Access Compliance Report

Public Rights-of-Way

Intersection ID: 20057	Main Street: ASSEMBLY_ST	Cross Street: BULFINCH_RD	Location: SW
ADA ID: A793541BB75C	Ramp Type: PerpDiag	Initial Pass/Fail: Fail	Overall Compliance: No
Severity Score: 10			
Codes/Mitigation Info/Possible Solution		Field Measurements/Component Compliance

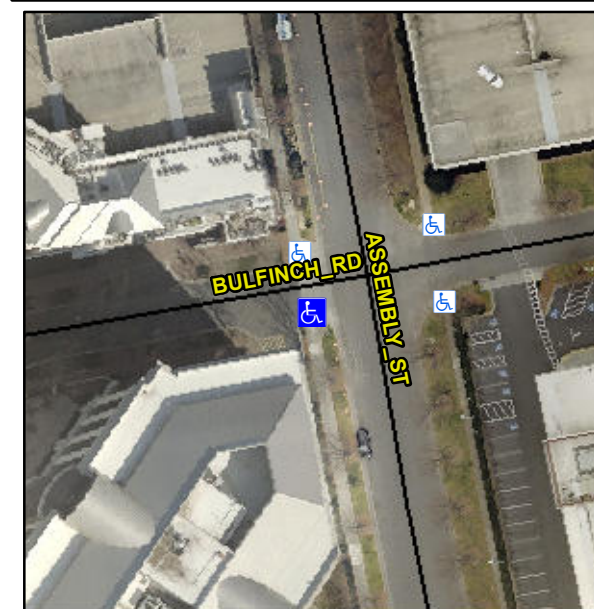
R304.5.1, R304.5.3

Compliance	Description	Data	Compliance	Description	Data
N/A	Ramp Length (in)	168.0	Yes	Ramp Slope (%)	7.1
No	Ramp Width (in)	47.0	No	Ramp XSlope (%)	2.7
N/A	Flare Type LT	N/A	N/A	Flare Type RT	N/A
N/A	Flare Slope LT (%)	N/A	N/A	Flare Slope RT (%)	N/A
N/A	Flare Traversable LT?	N/A	N/A	Flare Traversable RT?	N/A
N/A	Landing Length (in)	N/A	N/A	DWS Provided?	N/A
N/A	Landing Width (in)	N/A	N/A	DWS Contrast?	N/A
N/A	Landing Slope (%)	N/A	N/A	DWS Length (in)	N/A
N/A	Landing X Slope (%)	N/A	N/A	DWS Full Width?	N/A
N/A	Landing Curb? (Y/N)	N/A	N/A	DWS Offset (in)	N/A
N/A	Shared Landing?	N/A			
N/A	Gutter Ponding?	N/A	N/A	Gutter Slope (%)	N/A
N/A	Gutter Lip Ht (in)	N/A	N/A	Gutter X Slope (%)	N/A
N/A	Painted X Walk1?	No	N/A	Painted X Walk2?	No
	X Walk 1 Direction	To E		X Walk 2 Direction	To N
N/A	X Walk 1 Width (in)	N/A	N/A	X Walk 2 Width (in)	N/A
	X Walk 1 Slope (%)	2.5		X Walk 2 Slope (%)	1.9
	X Walk 1 X Slope (%)	1.5		X Walk 2 X Slope (%)	2.5

Remove & Replace Curb Ramp With Two New Directional Ramps or Equivalent.
